# MAKE-UP TABLE LIGHT SWITCH WIRING MODIFICATION

PRODUCT INFORMATION BULLETIN #7244

**Illustration A**  
Before modification

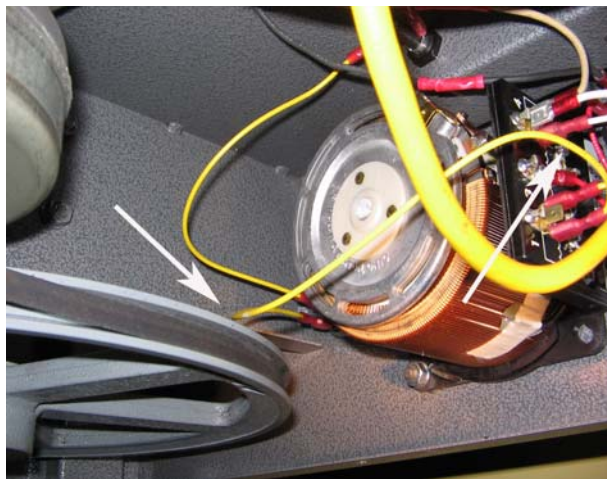
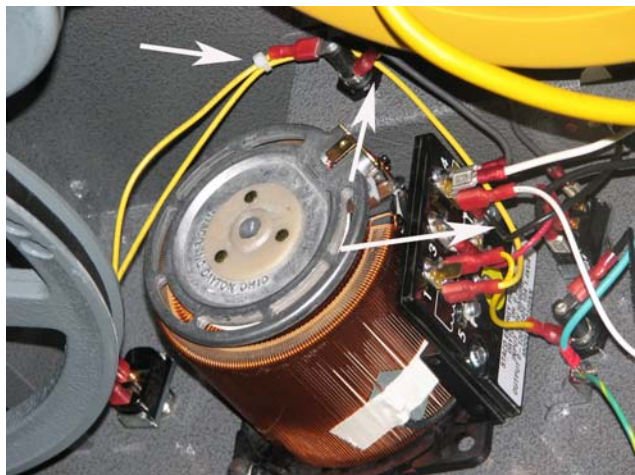
Make-up Tables with serial numbers between 20764 and 24031 may be wired so the light switch wire could contact the rotating drive sheave during operation, resulting in an electrical short which could cause serious injury.

Check the yellow wire from the light switch (see arrow in illustration A) for signs of rubbing. If the wire shows no signs of wear, disconnect the wire and re-route it behind the transformer and re-connect to the transformer. A cable tie should be used to secure the wire to the other yellow wire from the switch.

**Installation:** *Disconnect the table from the power supply.* Set the table on its back and remove the bottom cover. Remove the wire connecting the light assembly fuse to the light switch. Also remove the wire connecting the light switch to the transformer terminal number 1.

If the wire does show signs of wear, a wiring harness is available to eliminate the possibility of an electrical short. This will be provided free of charge by Design & Manufacturing, Inc. Order part number 6811.

Install the new harness so the short wire connects the fuse to the light switch terminal nearest the table top. Install the longer wire between the remaining switch terminal and terminal number 1 at the transformer (see illustration B).

**IMPORTANT:** Route the longer wire behind the light fuse as shown in illustration B.
